**Explanation of Significant Differences**

**Upper and Lower Harbor Operable Unit**

**New Bedford Harbor Superfund Site**

**Draft for Public Comment**

1. New Bedford Harbor ROD 2 proposed dredging areas and CDFs
2. Shoreline Facilities for Offsite Disposal
3. Shoreline Facilities for Onsite Disposal
4. Area D Dewatering/Material Transfer Facility

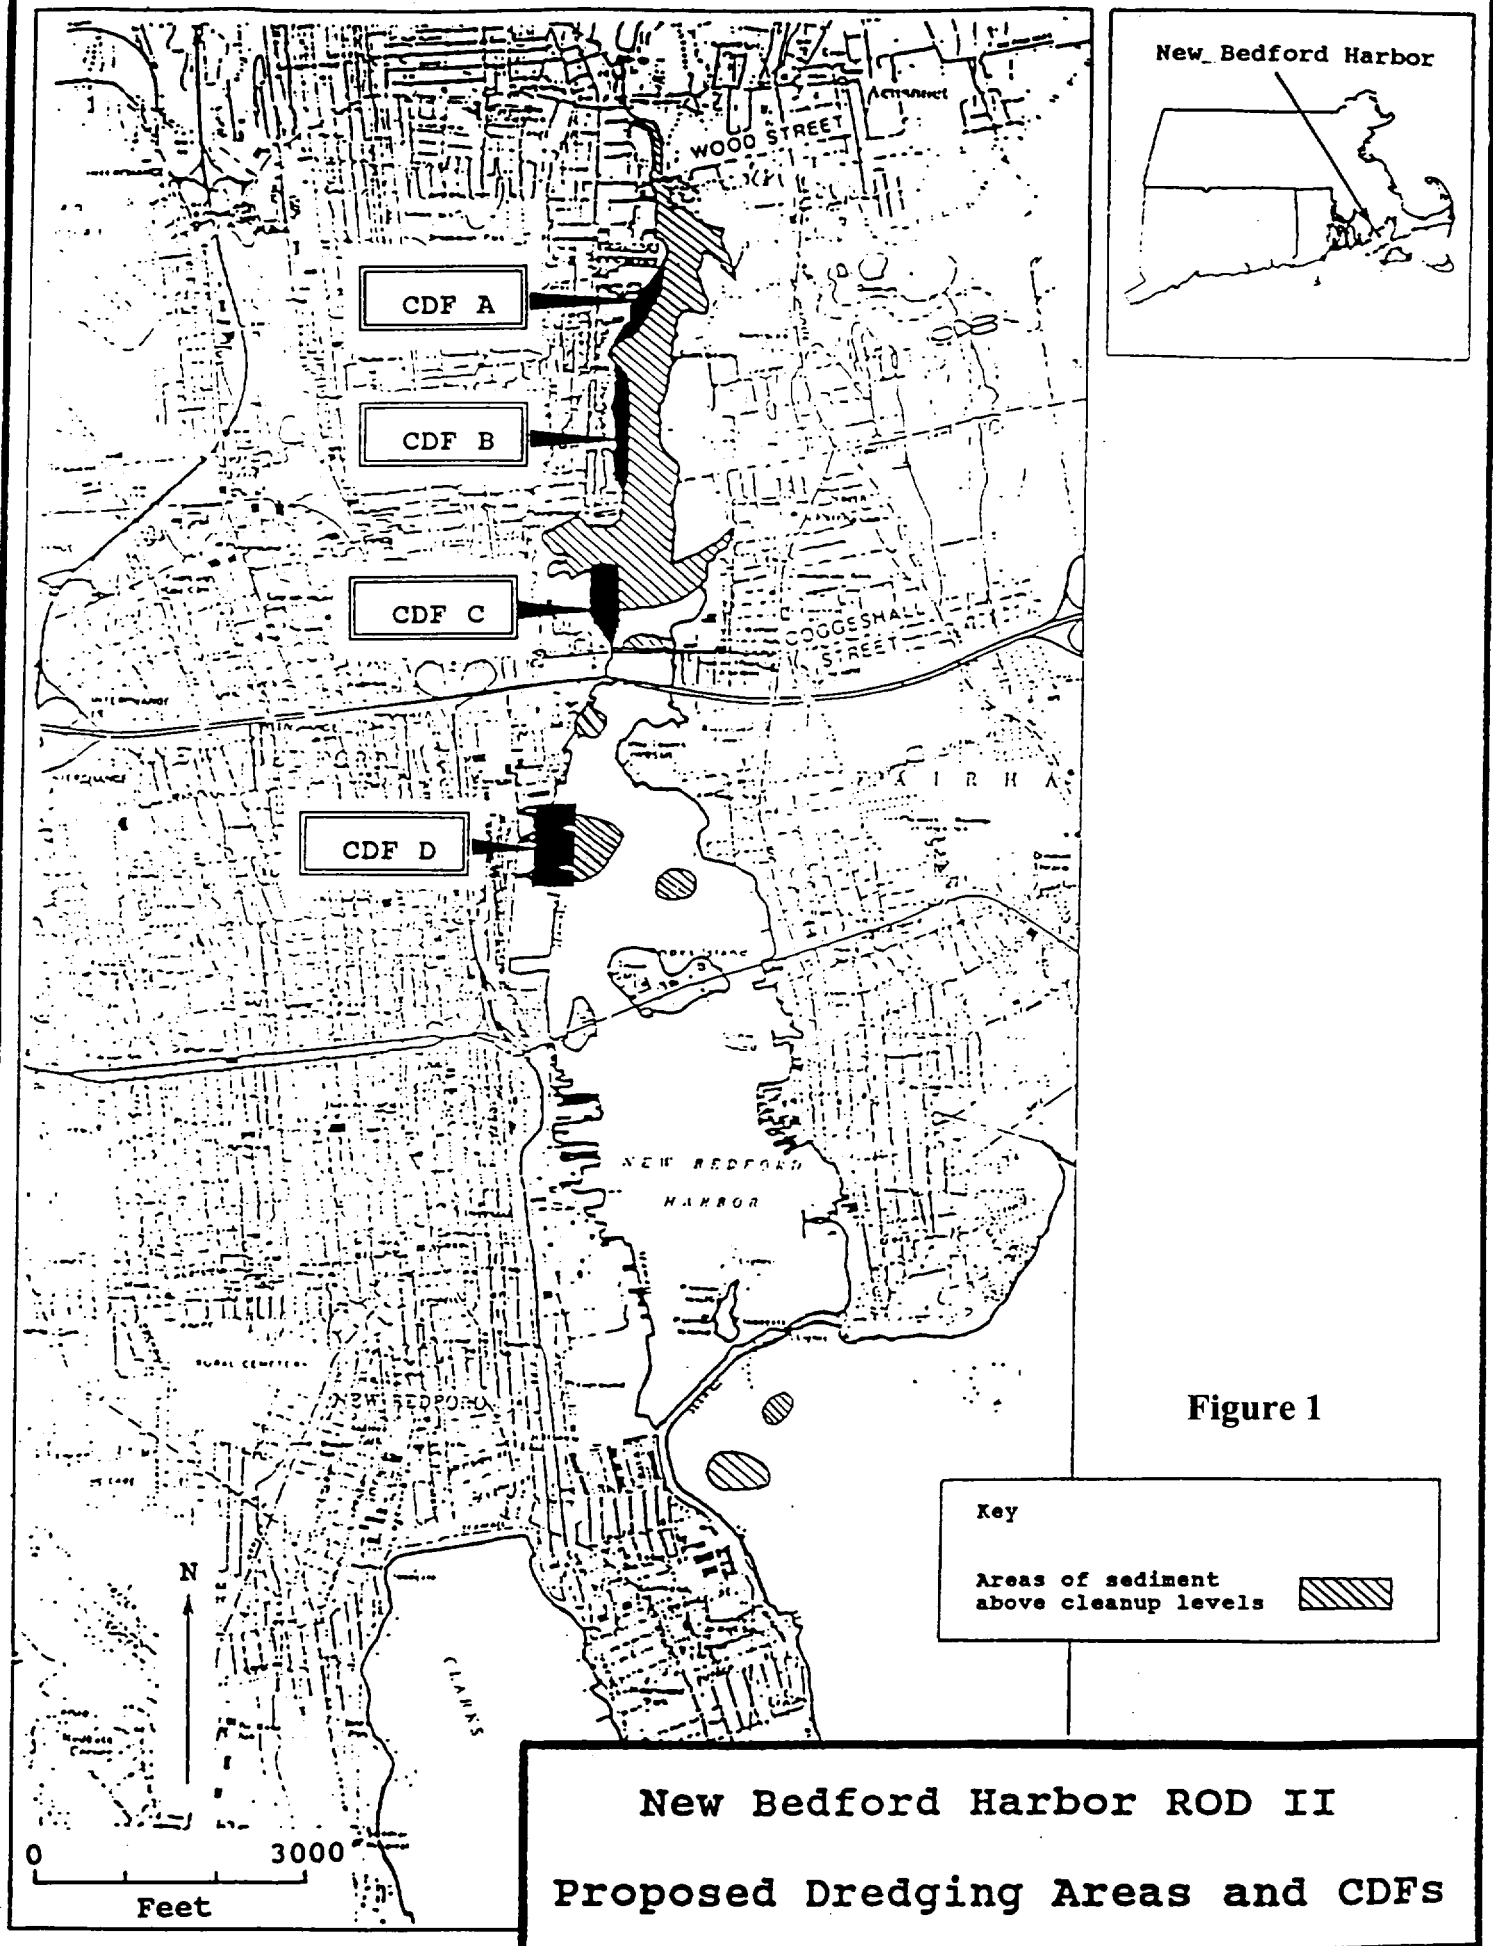
This proposed ESD for ROD 2 seeks public comment on EPA's assessment that offsite disposal for the dredged sediments slated for CDF D is a better approach for the harbor cleanup than constructing CDF D and disposing PCB-contaminated sediments in it. At approximately 17

As discussed above in Section I, the ROD originally called for the dredged sediments to be placed in four shoreline CDFs (CDFs A, B, C and D; see Figure 1). Seawater decanted from these sediments is to be treated to very stringent levels before discharge back into the harbor. The ROD also requires that institutional controls, including the continuation of a state-sanctioned fishing ban, be in place until PCB levels in seafood reach acceptable levels.

Figure 2  
Shoreline Facilities for Offsite Disposal  
February 2002 ESD

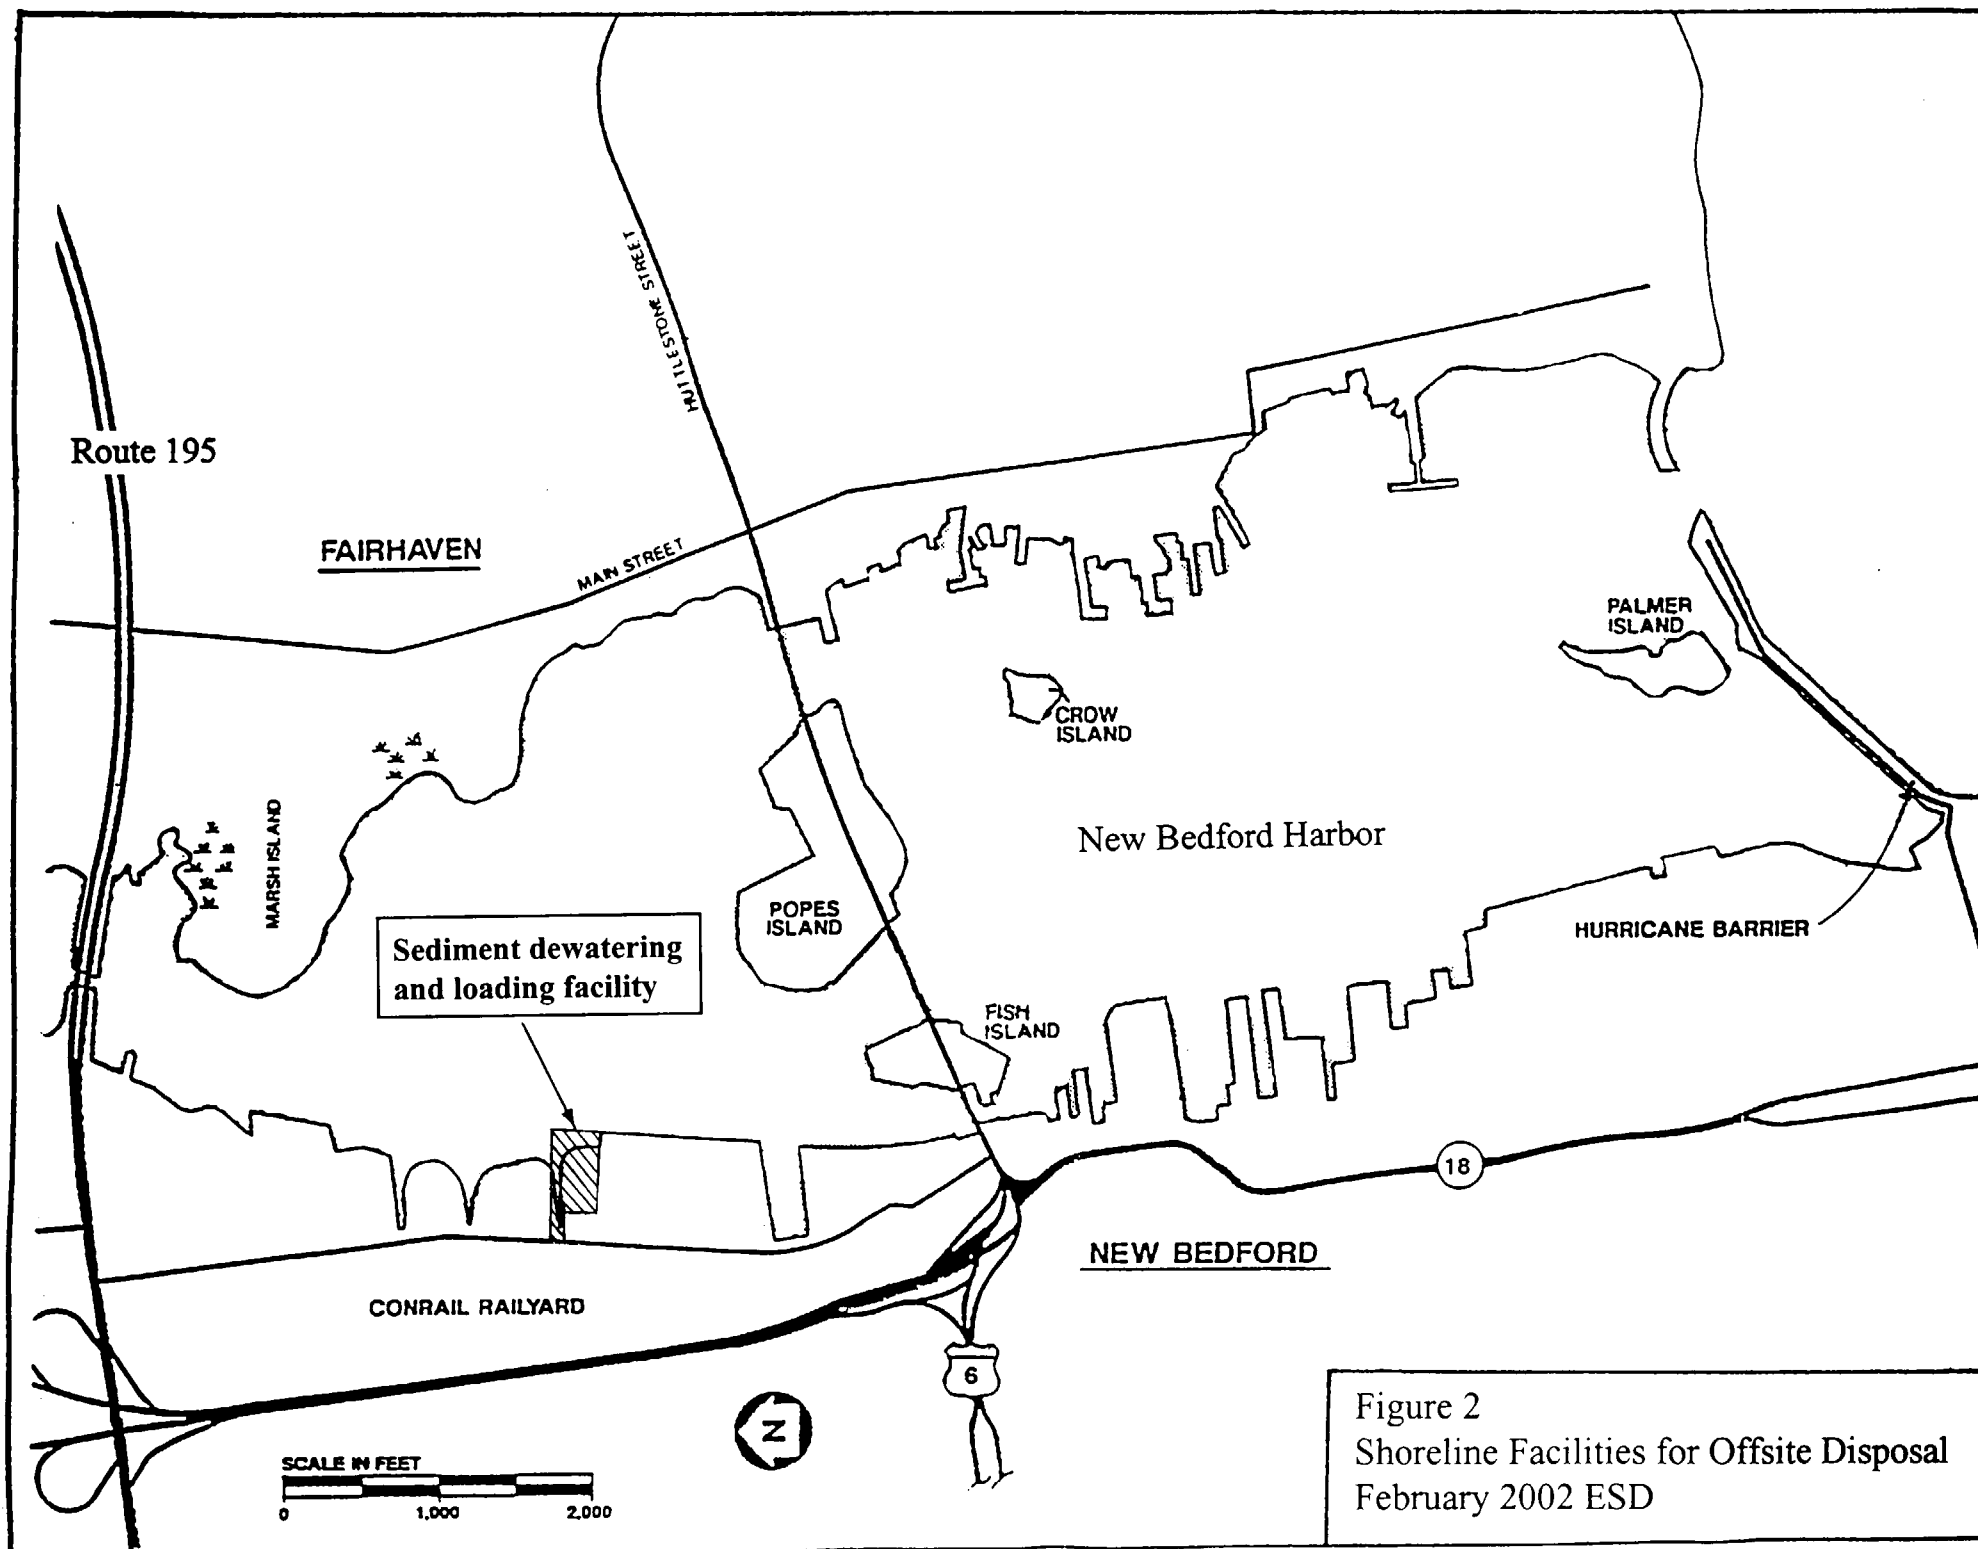
While this ESD proposes elimination of the 17 acre CDF D, it does not eliminate extension of the rail spur into this area discussed in the September 2001 ESD. If this proposed ESD is supported by public comment and incorporated into the remedy, a smaller shoreline facility would be constructed in the same area to support both the sediment dewatering building and the rail car (or truck or barge) loading area required for offsite disposal of the dredged sediments. See Figure 2 for the location of this smaller dewatering and loading facility. Figure 3 illustrates the larger area of fill that would be required for CDF D, based on its current conceptual design. Figure 4 provides a closer overhead view of the smaller dewatering and loading facility, as currently designed.

The most direct physical advantage of this ESD's proposed modification is that it reduces the required filling of intertidal and subtidal areas from the original 17 acres to only 2 acres. By expanding existing filled tidelands with an additional 2 acres of fill, both the sediment dewatering and offsite loading facilities can be located within a smaller area, with a net savings of 15 acres of tidelands that are no longer disrupted. See Figures 2 and 3 attached. This proposal to decrease the amount of filling, along with dewatering, is consistent with EPA's mandate under both state and federal laws to consider actions that are least damaging to the environment and to minimize, to the maximum extent possible, adverse environmental impacts.

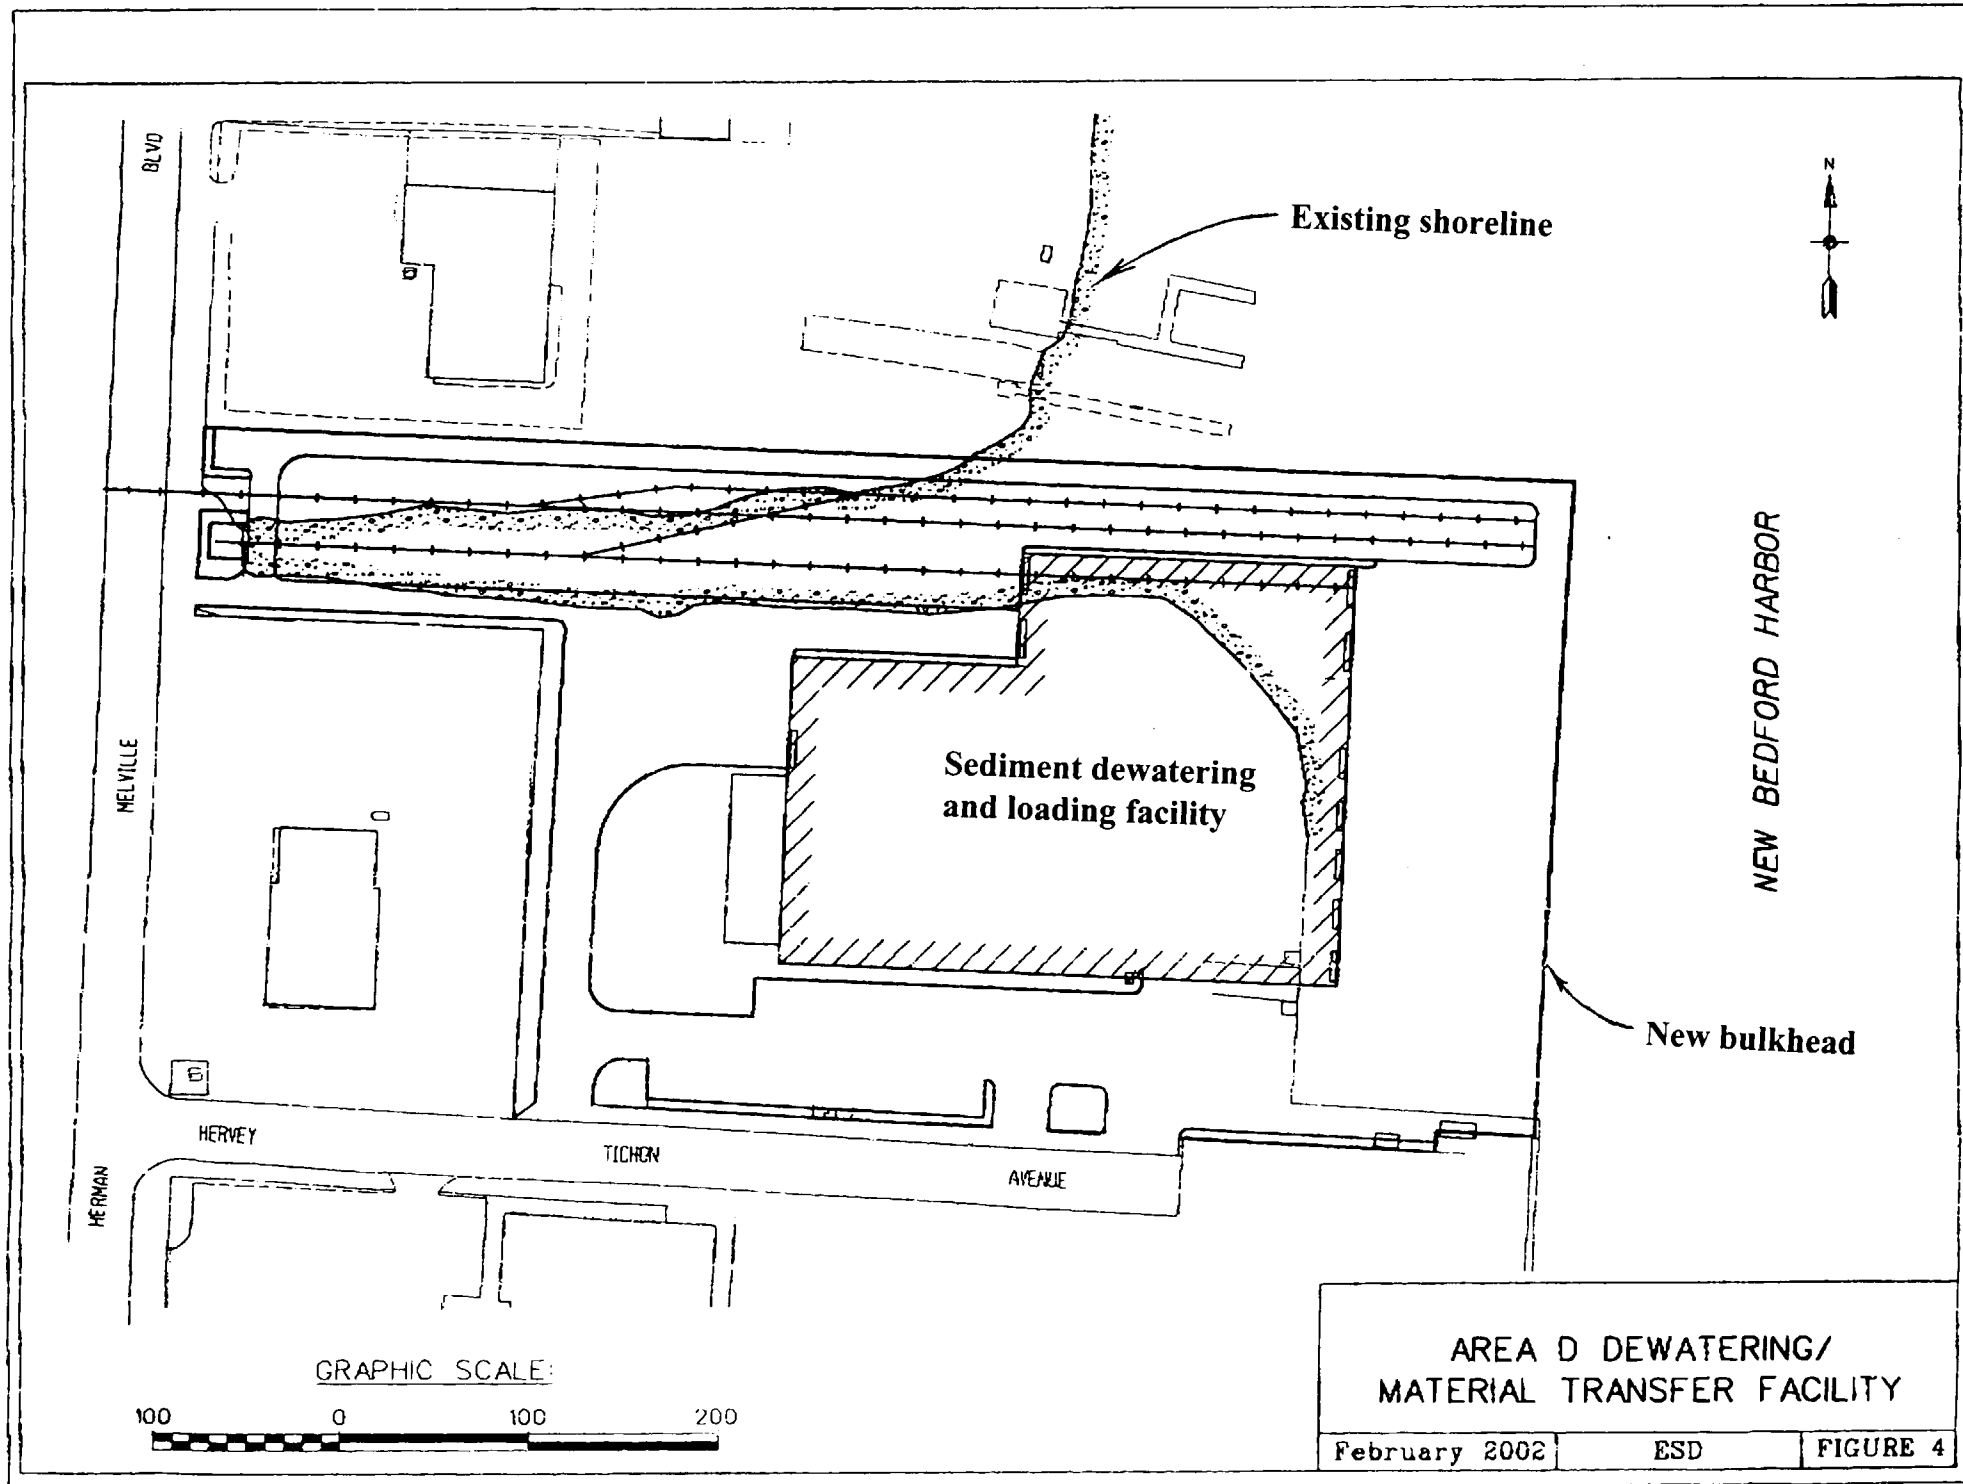
Under the offsite disposal option, the smaller scale shoreline facilities - the bulkhead, dewatering warehouse and rail spur - would be designed for future commercial marine reuse. Thus beneficial reuse of these facilities within the DPA once the cleanup is complete would be vastly streamlined and much less limited. Figure 4 shows a plan view of these features as currently designed.
